TO: Mercedes-Benz Dealer Principals, General Managers, Sales Managers, Service Managers, Parts Managers	FROM: Anthony Washington, Senior Manager, Regulations and Certifications
Re: Launch Recall Campaign Notification Model: Metris (447) Model Years: 2022-2023 Replace Fuel Delivery Module	DATE: April, 2024

Campaign No. :	Campaign Desc. :	Replace Fuel Delivery Module(dealer inventory only)
2024040005	VS2KRAPUM2	
<p>This is to notify you of a Recall Campaign Launch to replace the fuel delivery module on approximately 80 MY 2022-2023 Mercedes-Benz Metris vans. The recall campaign will be visible on the www.safercar.gov website and may generate questions from customers. All affected VINs will be flagged "OPEN" in VMI and cannot be sold until the recall has been remedied.</p>		
Background		
Issue	<p>Mercedes-Benz AG, the manufacturer of Metris vans, has determined that on certain Metris (447 platform) vehicles, the fuel pump impeller might not meet specifications in regards to material characteristics. As a consequence, the impeller might deform and come into contact with the fuel pump housing, leading to a mechanical resistance. In some instances, this could lead to a shutdown of the f

S47.20-A027-03

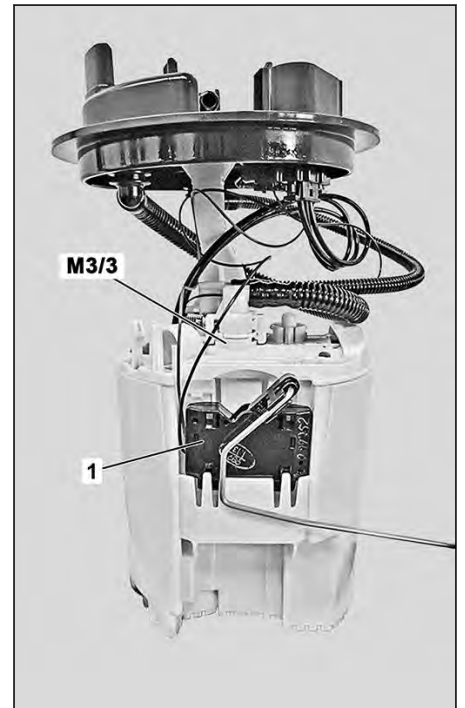
Remove		
4	Remove fuel pump with fuel delivery module (M3/3).	<p> Contrary to the statement in the reference document on removal of the fuel tank, the fuel hose (2) does not need to be removed.</p> <p>The filler neck (3) is only detached from the body and remains on the fuel tank.</p> <p> The removed fuel pump with fuel delivery module (M3/3) is not reused.</p> <p>Dispose of removed component parts that are not reused properly. Observe the applicable legal requirements and specifications of the relevant country.</p>	AR47.20-S-7000E

Modify		
5	Transfer fuel tank fill level sensor (1) of removed fuel pump with fuel delivery module (M3/3) to new fuel pump with fuel delivery module (M3/3).	Only if new fuel pump with fuel delivery module (M3/3) was delivered without fuel tank fill level sensor (1).	AR47.50-S-0111E

Install		
6	Install new fuel pump with fuel delivery module (M3/3).		AR47.20-S-7000E
